Final TAB Punchlist

Prepared by Jacob Davidson

Nov 4, 2024

IMG_9801

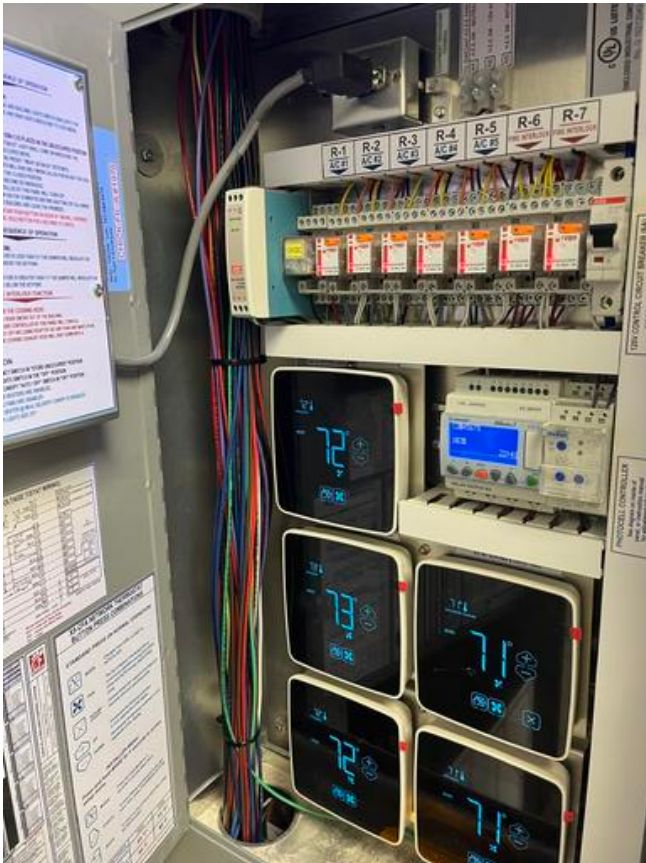
Line voltage cover in SEC low voltage panel is missing and needs to be installed (EC).

Sheet
MH-1.1

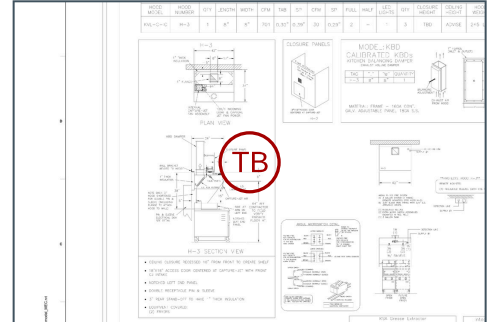
Description
Hoods not hung to design measurements from Halton shop drawing. Review hood height and make duct adjustments in riser to accommodate. Hood should be hung 64” according to drawings.

Sheet
M-501

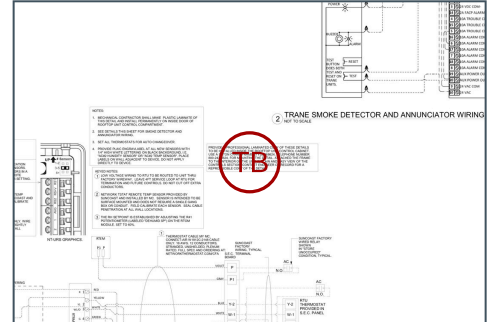
Description
Equipment missing laminated copy of controls detail low voltage wiring diagrams.

Sheet
P-250

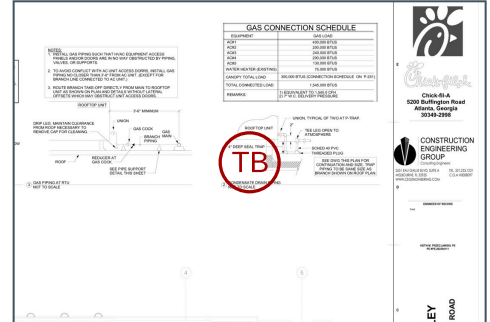
Description
Equipment condensate piping or p-trap is not constructed per normal CFA specifications.

Sheet
M-501

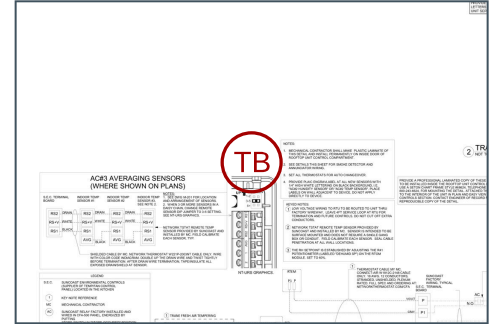
Label all sensors, humidistats, thermostats, smoke annunciators and remote space mounted OADs, MODs, VFD's for which piece of equipment they serve.

IMG_9737

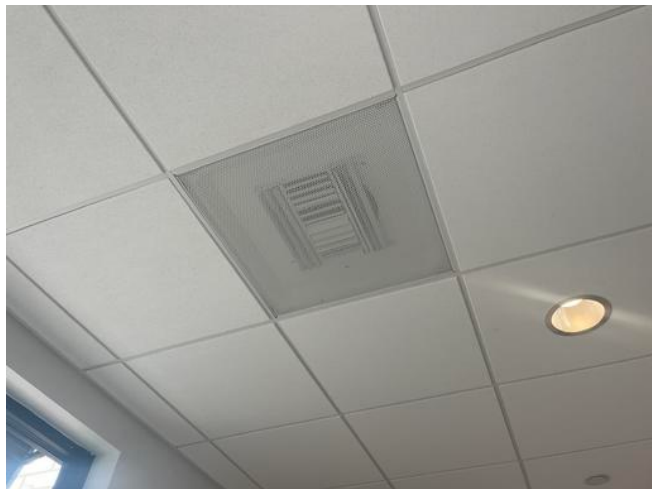
The RA and/or SA ductwork is dirty and needs to be cleaned.

Sheet
M-401

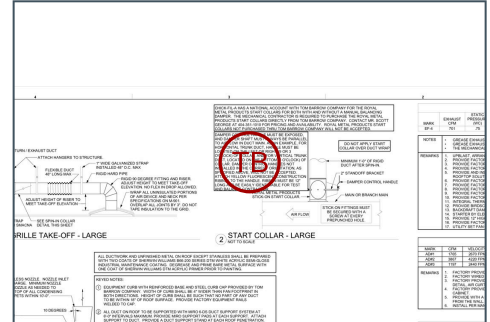
Description
Dampers are not flagged per specification.
